Action items from Session #43 and new introductory material for the Working Draft (802.16h-06/015)

Paul Piggin
NextWave Broadband Inc.

Figure 1 Flowchart algorithm for specific spectrum users.

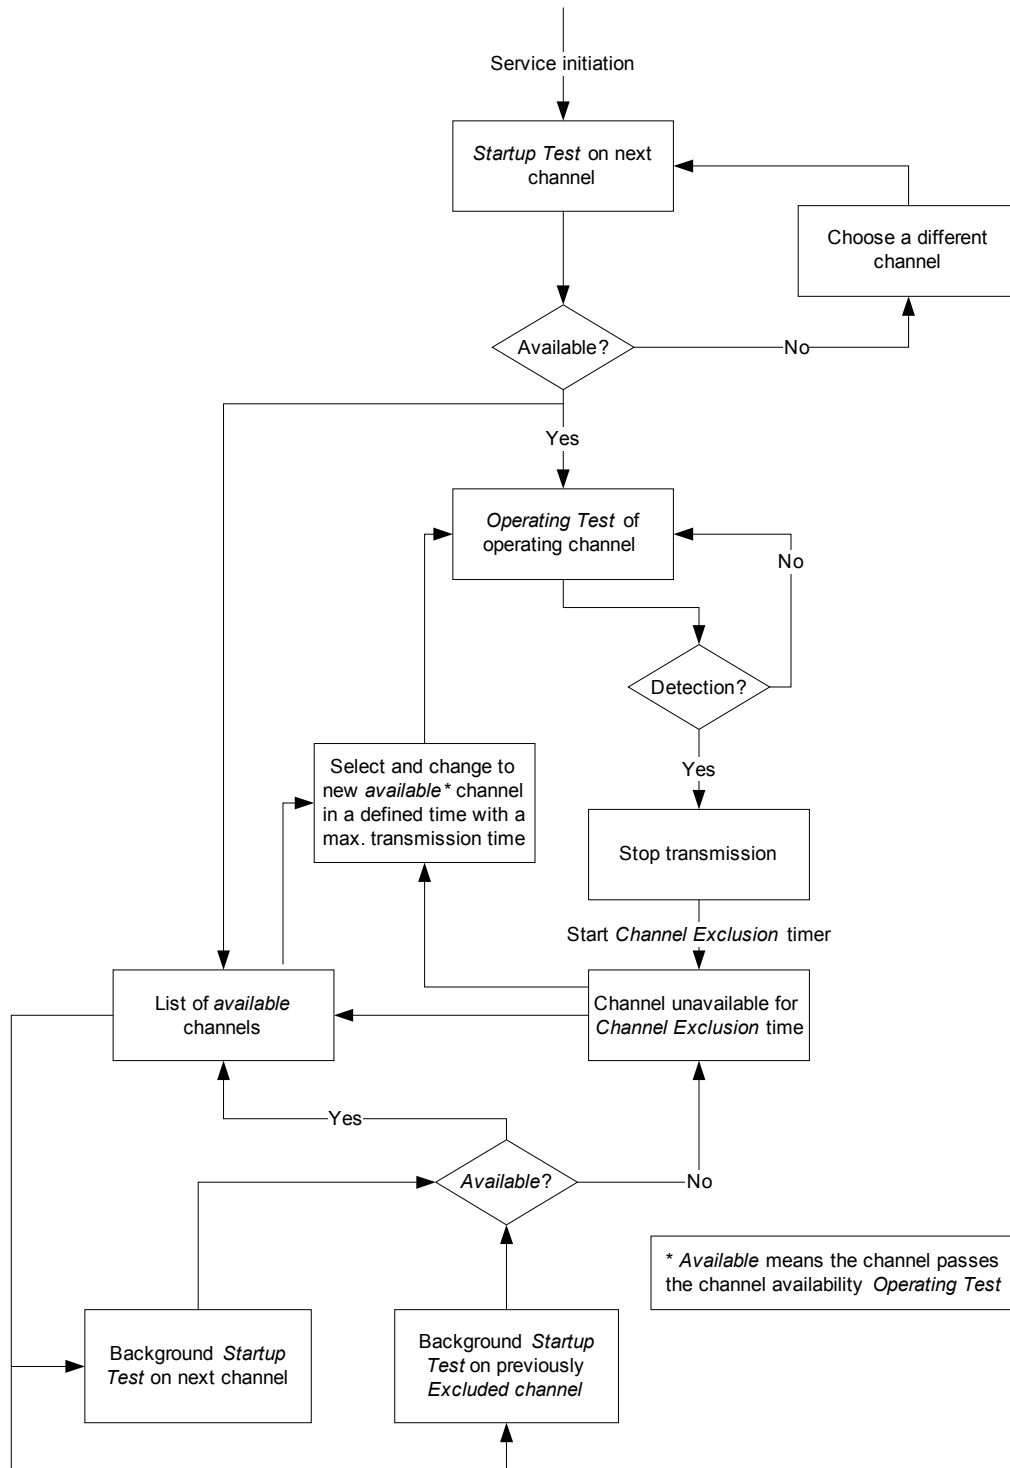
Figure 1 provides the replacement figure for the flowchart algorithm for specific spectrum users. This is Figure h1 in section 6.3.15 of [1].

Figure 2 Representation of extended channel numbering structure.

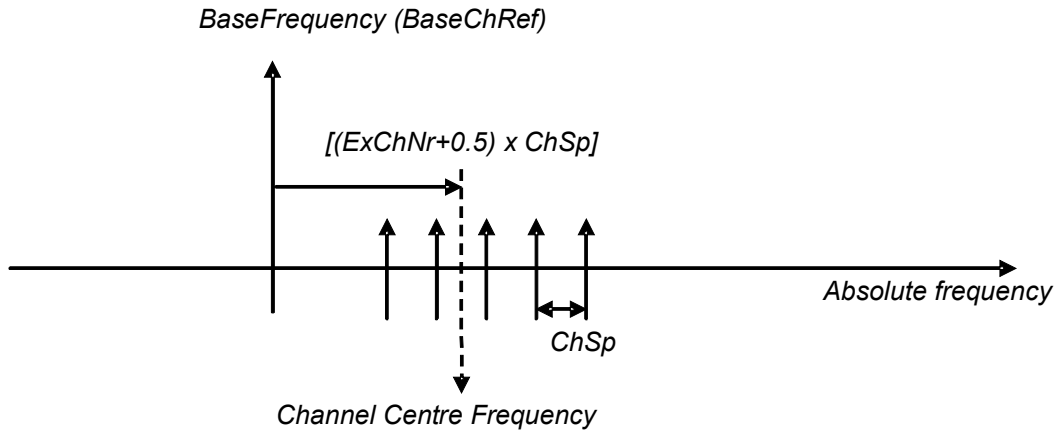
Figure 2 provides a replacement figure for the extended channel numbering structure. This is figure h2 in

section 6.4.1.2 of [1].
